Subject: **Palo Verde Nuclear Generating Station Units 1, 2, and 3
Docket Nos. STN 50-528, 50-529, and 50-530
Renewed Operating License Nos. NPF-41, NPF-51, and NPF-74
Response to Request for Additional Information to Proposed
Method to Manage Environmentally Assisted Fatigue for the
Pressurizer Surge Line**

**Response to Request for Additional Information to
Proposed Method to Manage Environmentally Assisted
Fatigue for the Pressurizer Surge Line**

NRC RAIs and APS ResponsesNRC EMIB-RAI-1

Figure RAI-3-1: Reactor Trip (Tran4) Pressure and Thermal Transient K vs Time History

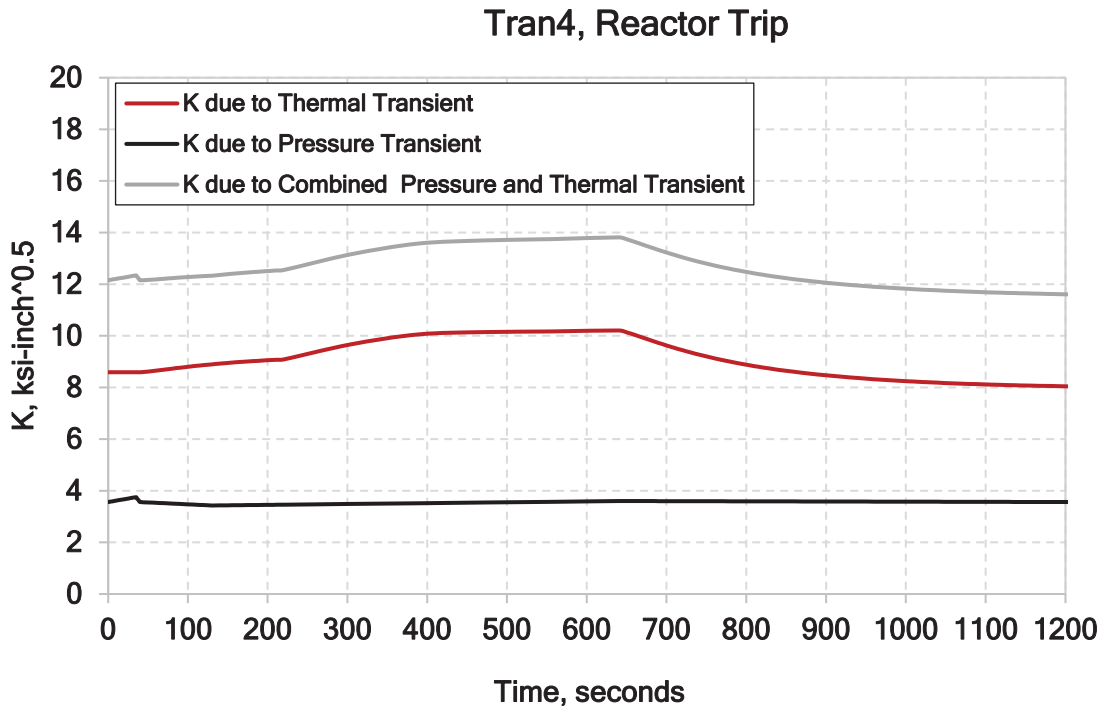
The NRC staff notes that the K_{max} (or K_{min}) for the thermal transient pressure and temperature may not occur at the same time, e.g., during cooldown the inside surface stress increases and pressure stress decreases. Therefore, the licensee’s combination of all the K_{max} (or K_{min}) values for different cases may not be adequate. Please clarify.

The K-values due to pressure and thermal transient were calculated separately. Time history stress analysis was performed for thermal transients only and the Structural Integrity Associates, Inc. (SIA) proprietary software SI-TIFFANY was used to calculate the K versus time history and $K_{max, thermal\ transient}$ and $K_{min, thermal\ transient}$. Another set of static stress analysis was performed for a unit pressure (1000 psi) loading. The K value under unit pressure loading was also calculated by SI-TIFFANY. K values for unit pressure are scaled to actual minimum and maximum transient pressures to generate $K_{max, pressure}$ and $K_{min, pressure}$.

For the crack growth analysis, the $K_{max, thermal\ transient}$ and $K_{max, pressure}$ (and similarly $K_{min, thermal\ transient}$ and $K_{min, pressure}$) values calculated and extracted from the transient runs are added together to represent the transient loading block of the event. This approach is conservative and recognizes that peak K values of pressure and thermal transient loading are calculated separately, and then combining them later, which excludes any reduction in K values at a specific time point due to out-of-phasing.

As an example of the methods conservatism, a K vs time history plot of Tran4 (Reactor Trip) for a flaw with $a = 0.1885$ inch as an initial crack, is prepared. Figure RAI-3-1 shows the K value due to the thermal transient separately, the pressure transient separately, and the K value due to the combined pressure and thermal transient run with concurrent thermal and pressure loading.

Table RAI-3-1 summarizes the K_{max} (and K_{min}) due to separate pressure and thermal transient runs versus the K_{max} (and K_{min}) due to the combined pressure and thermal transient loading. It can be seen that K_{max} (and K_{min}) due to the thermal transient alone, did not happen at the same time when K_{max} (and K_{min}) due to the pressure transient only occurred.

In SIA Calculation 2000645.304, Section 5.4 (Reference 4), and SIA Report No. 2000645.402 (Reference 9), K_{max} (and K_{min}) values due to the thermal transient only irrespective of time, and K_{max} (and K_{min}) values due to the pressure only irrespective of time, are calculated separately, and are then added as a conservative approach. As a result, the resulting K_{max} (thermal transient separately and pressure separately) is greater than the K_{max} due to the combined pressure and thermal transient run.

On the other hand, the resulting K_{min} (thermal transient separately and pressure separately) is less than the K_{min} due to the combined pressure and thermal transient run, which is conservative for K_{min} .

It is therefore concluded that the $\Delta K = K_{max} - K_{min}$ will then be greater with the combined largest K_{max} and smallest K_{min} .
